NAMPA DESIGN REVIEW COMMITTEE

Monday, January 17, 2023, 12:30 pm

2. Laguna Farms Mitigation: Discussion regarding façade details, not constructed on multiple apartment buildings at Laguna Farms, on a property located at 16852 Idaho Center Blvd, Parcel #R31041700000 DR-00102-2019 approved by Committee in August 2019.

Examples of some of the deficiencies:

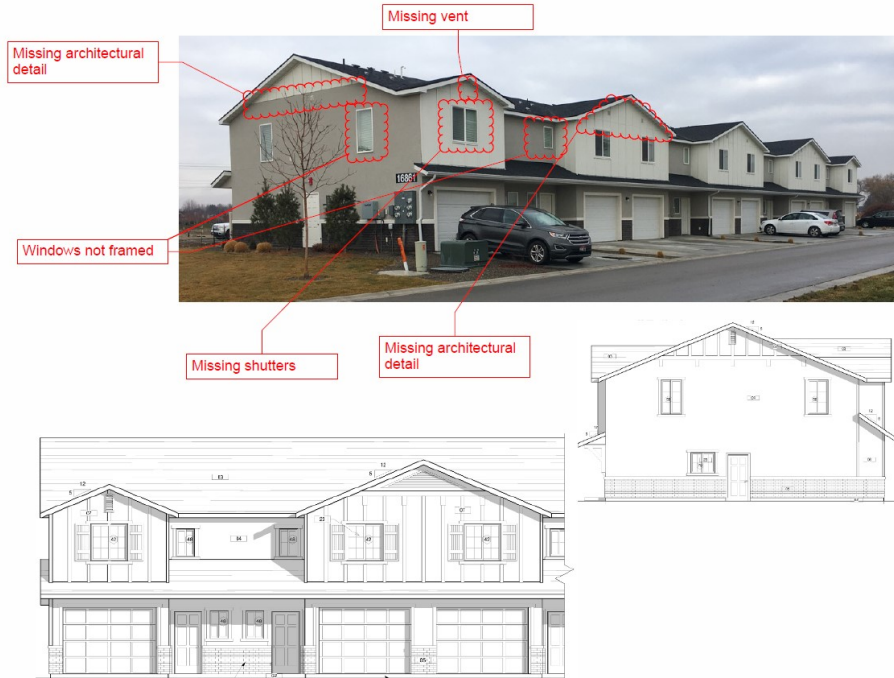
Principal Planner Watkins, presented the mitigation issue. Structures are non-compliant with approved elevations and construction plans.

The entire project is in different phases of construction from occupied to framed. Currently, 6 buildings are occupied and 4 are near completion. The rear elevation of the 12-plex and the right and left (corner) elevations of the 8-plexes will be the elevations that will be most visible from the CWI property and portions of Idaho Center Blvd. If these are to be considered the primary façades of the buildings, they do not meet the requirement for the 50% façade changes.

The 12-plex does meet the 30% requirement for other wall faces. The 8-plex left/right elevations only provide 13% façade change on the Tucker style and 21% on the Delinda style.

1. Add architectural details as shown on the original approved plans:
 - a. Shutters
 - b. Additional brick around the buildings
 - c. Architectural border details under the rooflines
 - d. Painted banding (with architectural details) on the side walls
 - e. Garage canopies/pergolas
 - f. Dividing fence walls between units
 - g. Framed windows
 - h. Vents (or the appearance of vents)

2. The roofline and window popouts were not addressed during framing and cannot be corrected at this late date.

- Hatch: Add angle braces to the buildings already built out which were on the plans and approved elevations. (Veloz clarified that the buildings not built out must meet the previously approved criteria).

- Buildings during framing stage must meet original approval (only mitigation at this point for those buildings would be a “physical popout.”)
- Gable wanted to know why the owner of project gave the builder different plans than what the City approved.
- Hatch-Possible mitigation (including staff recommendations): Add an architectural eyebrow along the roofline with changing materials to give the appearance of a bumpout.

- Add shutters.
- Additional brick around the buildings.
- Architectural border detail under the roofline including angle braces.
- Painted band architecture on the sidewalls.
- Garage canopy/pergolas.
- Divided fence walls between buildings.
- Framed windows.
- Vents (or the appearance of vents).
- Rooflines at the entry.
- Appropriate treatment to create a faux popout with similar details to what was previously approved.
